Access Compliance Report

Public Rights-of-Way

Intersection ID: 15984	Main Street: LANIER_AV	Cross Street: UNAKA_AV	Location: SW
ADA ID: 44B18643D8F2	Ramp Type: Directional1	Initial Pass/Fail: Pass	Overall Compliance: No
		Severity Score: 7.5

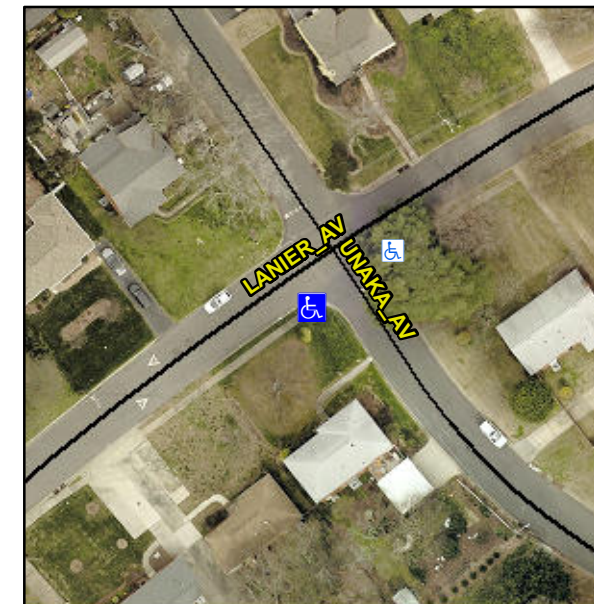
**Not Found, R304.2.2-Perp, R304.3.2-
Para, R304.5.3, R305.1.4, R305.2,
R304.5.4**

Compliance	Description	Data	Compliance	Description	Data
N/A	Ramp Length (in)	40.5	Yes	Grade Break?	Yes
Yes	Ramp Width (in)	48.0	Yes	Grade Break Slope (%)	2.9
Yes	Ramp Slope (%)	2.2	No	Grade Break XSlope (%)	3.6
Yes	Ramp XSlope (%)	1.4			
N/A	Flare Type LT	N/A	N/A	Flare Type RT	N/A
N/A	Flare Slope LT (%)	N/A	N/A	Flare Slope RT (%)	N/A
N/A	Flare Traversable LT?	N/A	N/A	Flare Traversable RT?	N/A
Yes	Landing Length (in)	68.0	Yes	DWS Provided?	Yes
Yes	Landing Width (in)	48.0	Yes	DWS Contrast?	Yes
No	Landing Slope (%)	4.4	Yes	DWS Length (in)	24.0
Yes	Landing X Slope (%)	0.3	No	DWS Full Width?	No
N/A	Landing Curb? (Y/N)	No	Yes	DWS Offset LT (in)	18.0
N/A	Shared Landing?	No	No	DWS Offset RT (in)	4.0
Yes	Gutter Ponding?	No	No	Gutter Slope (%)	6.2
Yes	Gutter Lip Ht (in)	0.0	No	Gutter X Slope (%)	2.4
N/A	Painted X Walk1?	No		Road Slope (%)	9.4
	X Walk 1 Direction	To NE		Road X Slope (%)	2.6
	X Walk 1 Width (in)	N/A		Clear Space?	Yes

**Remove & Replace Entire Ramp.
Remove & Replace Gutter.**
